Subject: Revised manuscript with the reference number: nhess-2021-351

We would like to thank you for giving us an opportunity to revise our manuscript. We have addressed all the concerns comments and would like to submit our revised manuscript entitled "**Probabilistic Fault Displacement Hazard Analysis for North Tabriz Fault**" for further consideration. We have modified the manuscript thoroughly by considering all of the comments raised by the reviewers and editor which indeed improved the manuscript. In the following we respond to the comments in details.

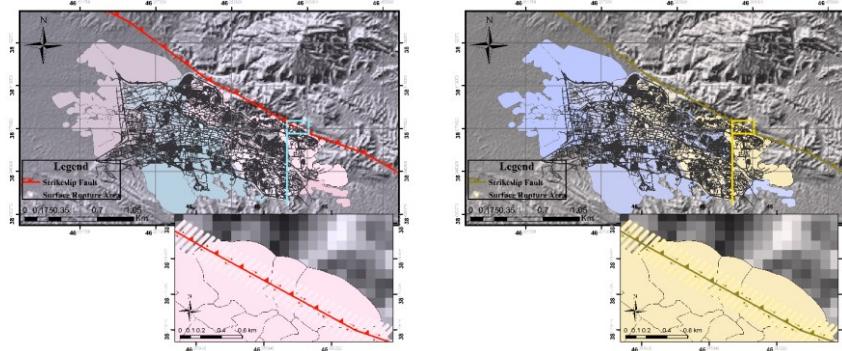
For figure 1, please ensure that the colour schemes used in your maps and charts allow readers with colour vision deficiencies to correctly interpret your findings. Please check your figures using the Coblis – Color Blindness Simulator (<https://www.color-blindness.com/coblis-color-blindness-simulator/>) and revise the colour schemes accordingly.

For this comment of yours, we used the site (<https://www.color-blindness.com/coblis-color-blindness-simulator/>) to get figure 1, allowing readers with color vision deficiencies to interpret our findings correctly, and through (Blue-Blind/Tritanopia and Red-Blind/ Protanopia) we got two figures for different color spectrum. Finally, we chose the first figure for the article. We have added these two images here so we can discuss them in case of your following comments.

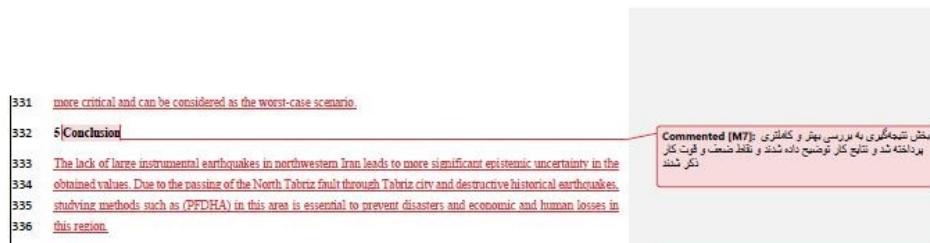
In the tracked changes file there is a non-English text as a comment. As your manuscript language is English please present the comments in English.

We have fixed this weakness for you

Figure 9. Comparison of drop in displacement values in scenarios, a) 50years, b) 475years, c) 2475years

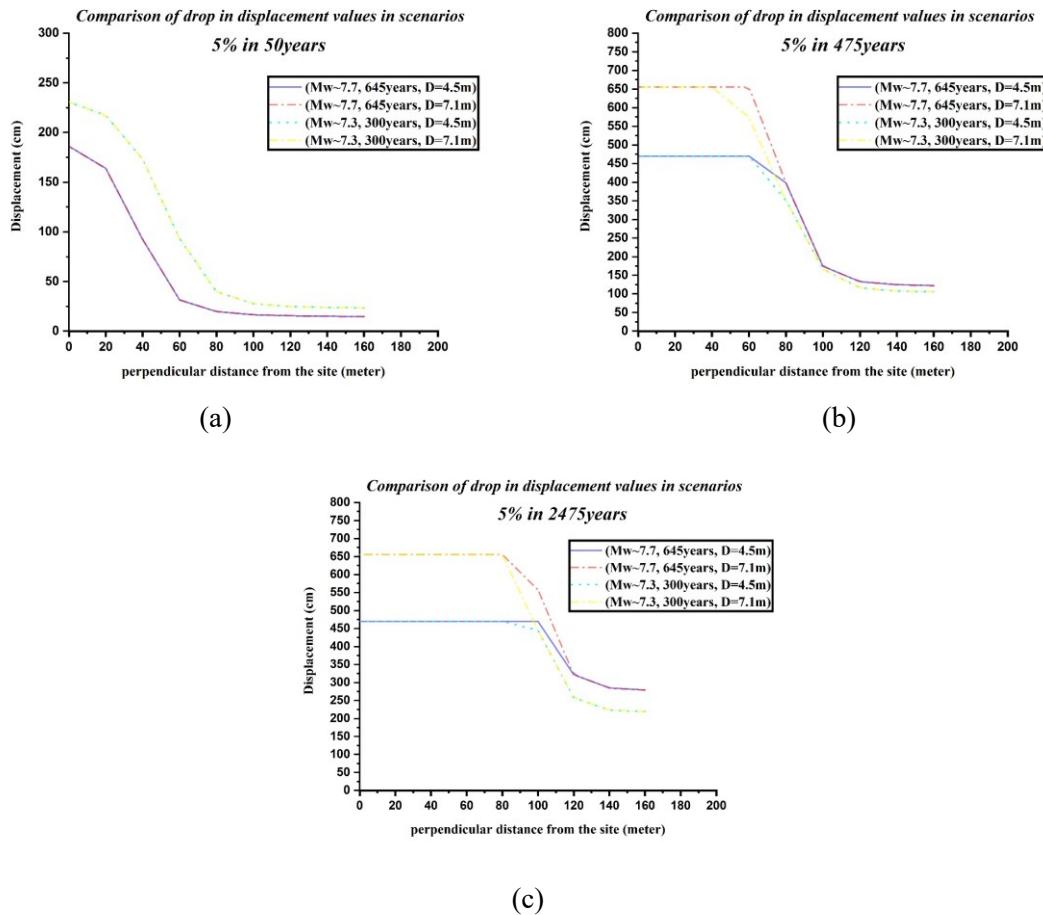
4) The section Results and Discussions is very poor. There is no discussion about the results and, for me, it has been very hard to understand how input parameters are considered and which equations are used. This paper could help the seismic hazard local community but it need a major review in order to make the manuscript clear and readable. Reading the paper I have the feeling that most of things are omitted and not well described.

To explain the results obtained more clearly, we added Figure 9 which examines and compares the results obtained for two different scenarios and identifies the worst case and will have a better description of the results obtained. Please see the "Results and Discussions" of the annotated manuscript.
